19 01788 AS Wates Site Tenterden Landscape Officer comments in response to SJA Investigation into Root System of T312 Oak Landscape Officer 17 06 2020

SJA Arboricultural Technical note - Investigation into Root System of T312 Oak June 2020

Figure 1

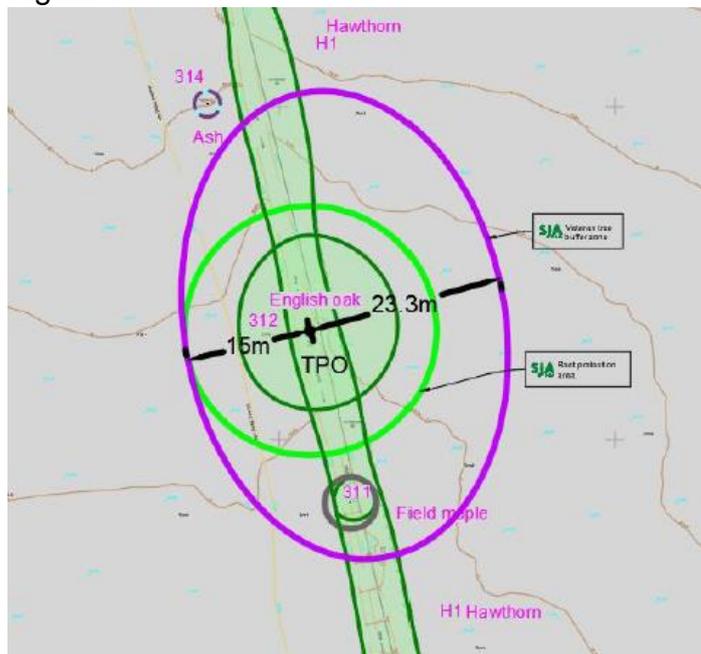
Within the SJA June 2020 Technical note in figure 1. a more regular ovate shape is offered as the buffer zone for T1 as shown below on the left with the Landscape Officer's outline sketch for comparison in figure 2.

Whilst this offers the minimum distance to the tree of the buffer zone of 23m - which is the applicable distance if the buffer zone was not offset, this does not address the Landscape Officer's viewpoint that the veteran tree should have the maximum distance possible around it to separate it from the developable area. The reasons relating to this approach are listed in the Landscape Officer's response of 27/05/2020 and for convenience is copied below in appendix 1.

Furthermore, the ovate shape still encompasses a large section of the hedge line that it need not and the shape seems to favour impacting the developable area to the east as little as possible. The Landscape Officer has justified an approach whereby the buffer zone will be approximately 31m from the stem of the to the east aspect using the following calculation as its basis: 46m diameter buffer zone – 15m RPA to west = approximately 31m to the east aspect.

The suggested morphing illustrated in figure 1 does not address the Landscape Officer's view that the distance to the veteran tree from the developable area should be maximised using the calculated area of the buffer zone of 1662m² – this results in a maximum distance from the middle of the stem of 31m. It must also be remembered that the buffer zone as calculated using the 15 x diameter of the veteran tree is a *minimum* as set out in the NE/FC Standing Advice and the LO in seeking to maximise the distance to the developable area is ensuring that the quality and status of the tree is fully respected – there is a clear case for the LPA seeking *more* than the minimum area given the importance of the tree that the LPA has not sought to pursue.

Figure 2.

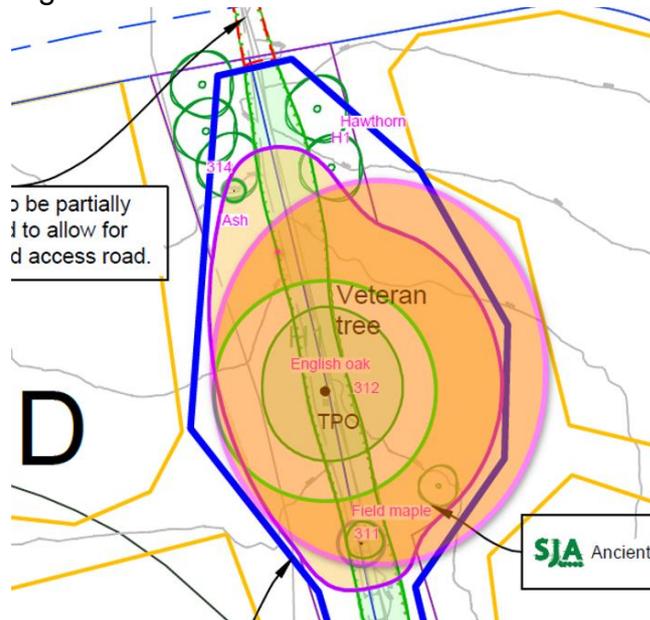
A maximised buffer zone from the centre of the tree as drawn in outline in the Landscape Officer's response dated 16/04/2020 and shown in figure 2 above will ensure the maximum distance to the developable area. The quality of the veteran tree is clearly described in the SJA AIR as:
